1. Claim of Priority to '951 Application

2. Figure 2 Drawing

Patent Application for: FULL WRAPPING DISPOSABLE REFASTABLE
AND ADJUSTABLE PANT
Inventor(s): Datta et al.
Attorney Docket No.: 659-829 & Kimberly Clark Ref. No. 14-104-1

Figure 2 Drawing (Amended 9-30-02)

Fig. 1A

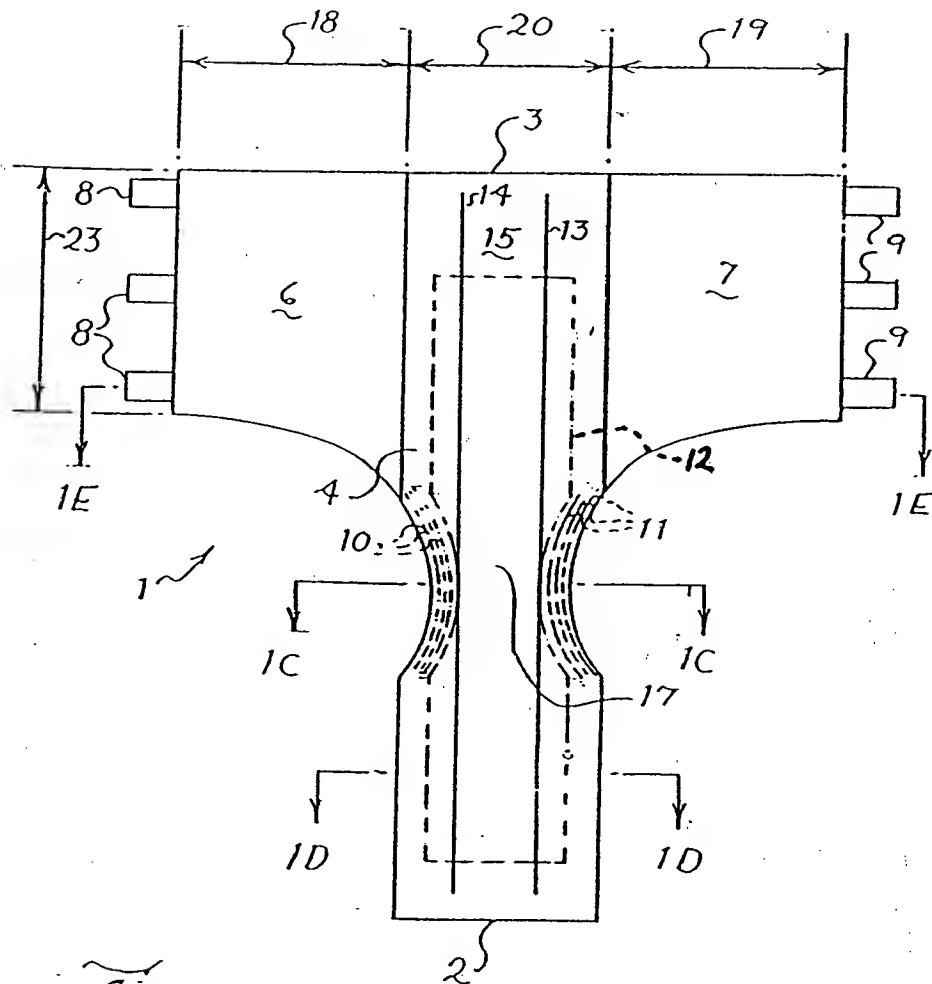
The drawings are objected to because in Figure 1A, the top layer of the chassis designated 15 and 12 and the absorbent pad is not designated 12. Element 5 in Figures 1B and Figure 2 are not consistent. Element 1 shown in Figures 1A and 1B and that in Figure 3 are inconsistent. A proposed drawing correction or corrected drawings are required in reply to the Office Action to avoid abandonment of the application.

Applicants have amended Figure 1 so that 12 now appear with dashed lines to indicate that it is underneath 15. Figure 2 and the corresponding disclosure in the specification have been amended to change the designation for the front panel from 5 to 51. In figure 5 the outer member serves as the fastening panel. Support for this embodiment is expressly found at page 4, line 2, and in the drawing of figure 2, as originally submitted. (Designation 51 is not used in any other figure). Plaintiffs have amended Figure 3 and the corresponding text in the specification to change the designation from 1 to 111. (Designation 111 is not used in any other figure). Thus, Applicants have overcome the objections to the drawings set forth in Item 4.

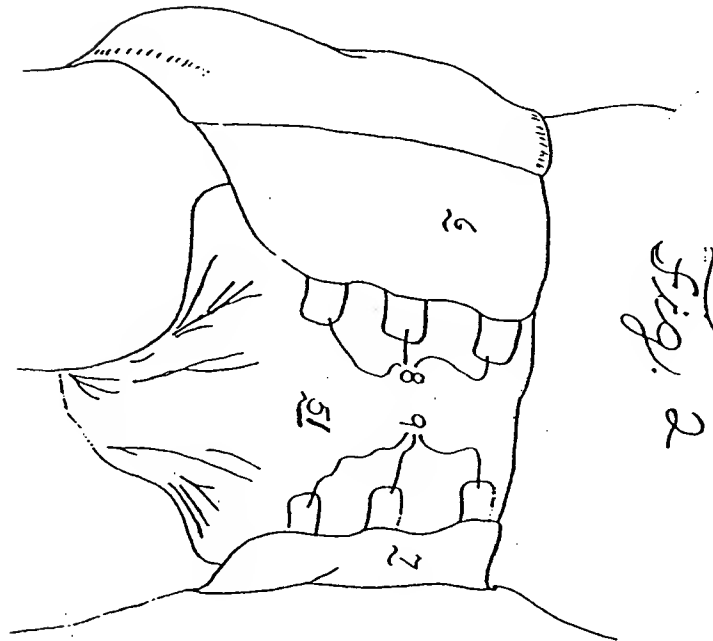
If Applicants maintains the request to have Figure 2 approved as proposed 9-30-02 the nature of the invention shown in Figure 2 would be much clearer if on page 4, line 2, after "panel", -- , see Figure 2 – could be inserted.

The proposed drawing correction and/or the proposed substitute sheets of drawings, filed on 9-30-02 have been approved in part (Figures 1A and 3 only). A proper drawing correction or corrected drawings are required in reply to the Office action to avoid abandonment of the application. The correction to the drawings will not be held in abeyance. . . **The drawing change proposed for Figure 2 was not approved because such gave two different designations to the same front end fastener.**

The drawings are objected to because element 5 in Figures 1B and 2 are not consistent, i.e. a square like that shown in Figure 1B should be labeled 5 in Figure 2. A proposed drawing correction or corrected drawings are required in reply to the Office action to avoid abandonment of the application. The objection to the drawings will not be held in abeyance.

With regard to Item 3 and Item 5, second full paragraph, the understanding of the invention is based on the disclosure of the invention in the specification. Applicants have not described the front fastening panel in Figure 2 as being a different embodiment nor pointed out such at the disclosure on page 4, line 2, which line is a description of the fastener 5. The Examiner's objection to the proposed Figure 2 in paragraph 2 of the FINAL, the objection to the originally filed drawings in paragraph 3 of the FINAL and the objection to the original specification as amended 9-30-02 in paragraph 4, item 2), of the FINAL are based on such description. If Applicant maintains the request to have Figure 2 approved as proposed 9-30-02 the nature of the invention shown in Figure 2 would be much clearer if on page 4, line 2, after "panel", --, see 51 in Figure 2 -- could be inserted.

The Examiner's parting comment is ambiguous and places a cloud over Applicants' case. There is no ambiguity in the specification and Applicants request the approval of Figure 2 (as submitted on 9-30-02), without any changes to the specification. Moreover, the Examiner's gratuitous comment that "the nature of the invention shown in Figure 2 would be much clearer" is totally improper. This comment has no basis in fact or law. At

The Examiner's objection to the amendment to Figure 2 shows a fundamental misunderstanding of Applicants' invention, the disclosure in Applicants' specification and Item 4 of Applicants' September 30, 2002 Response. A separate patch of material to serve as a landing member is not part of the embodiment shown in Figure 2. Thus the closure mechanism of Figure 2 works without the need for a separate patch of material, i.e. the patch of material shown as number 5 in Figure 1D is not needed nor intended to be in Figure 2. Moreover, support for the drawing of Figure 2, without a separate patch of material, is expressly found at page 4, line 2 of the specification, which provides: "[a]lternatively, an outer member may serve as the fastening panel." Thus, contrary to the Examiner's assertion, a drawing of Figure 2 is not required or intended to have a "separate square like that shown in Figure 1B." Such a separate square is not needed for the closure mechanism to function. . . Accordingly, amended Figure 2, which does not show a separate material, is correct as drawn.
